Memorandum – Unified Development Review

To: City Plan Commission
From: Brianna L. Valcourt, M.Arch; Senior Planner
Date: July 30, 2024
RE: "Replat of Lots 86, 87 & 88 Pirce Plat" – Assessors Plat 12/2, Lots 1796, 1797 and 1798
Minor Subdivision with Street Extension: Preliminary Plan
Application for Dimensional Variance

PRELIMINARY
 MINOR SUBDIVISION
 REPLAT OF LOTS 86, 87 & 88
 " PIRCE PLAT "
 0 MACERA DRIVE
 A.P.12 LOTS 1796,1797 & 1798
 CRANSTON, R.I.

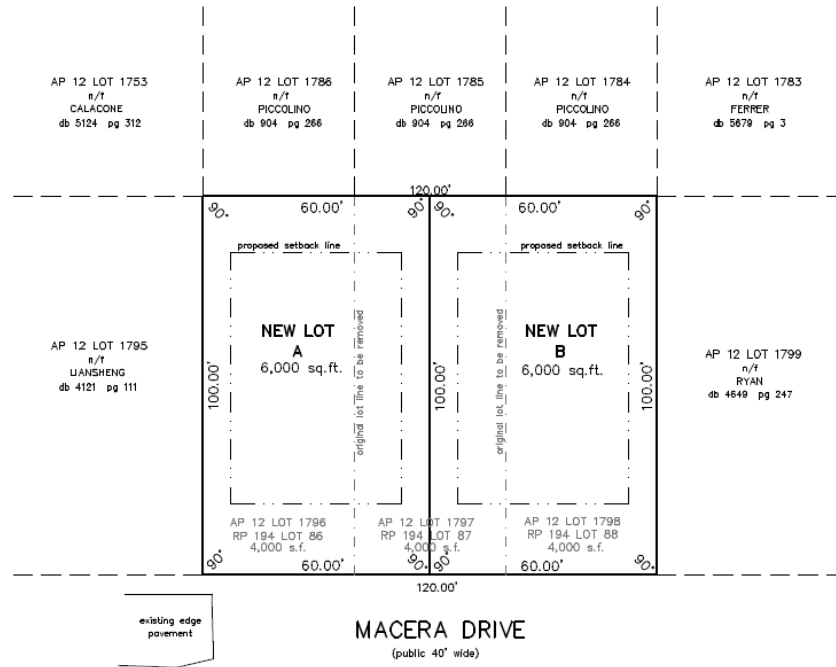
1. Department of Public Works
 - a. Engineering Division: Mr. Justin Mateus, P.E., Public Works Director, reviewed the Proposal with Staff and addressed that evidence of a water and sewer supply is still needed.

- b. Traffic Safety Division: Mr. Steven Mulcahy has provided commentary that states a street extension is required to develop the dwellings of this subdivision. At a minimum, a cul-de-sac is required on Macera Drive and must be located past the driveway entrance of both dwellings. Ideally, the street would be extended as a throughway from Yeoman Avenue to Vera Street, making Macera Drive a highly accessible improved city street.

- c. Sewer Division: Mr. Edward Tally, Environmental Program Manager, reviewed the Proposal and determined that the submission of a sewer design is to be reviewed and approved by the DPW Department and states that a letter from Viola Water is still needed at this time.

- d. Providence Water Supply Board: PWSB has not provided commentary at this time. Evidence of a water supply line on the Existing Conditions Plan is still needed. Staff notes that correspondence will be provided with the Final Plan application regarding suitable supply.

1. Submission of letters of availability from the Providence Water Supply Board for water availability and sewer main extension approval from Veolia Water, respectively.
2. Submission of complete engineering for street extension, including road profiles and drainage.
3. Class I Survey is to be conducted and submitted.
4. Submission of performance guarantee to be reviewed and approved by the DPW and Finance Departments prior to Final Plan recording for the street extension.
5. Payment of the Eastern Cranston Capital Facilities Development Impact Fee of \$593.46 x 2 (\$1,186.92)
6. The Final Plan Application will be considered by the City Plan Commission prior to recording.
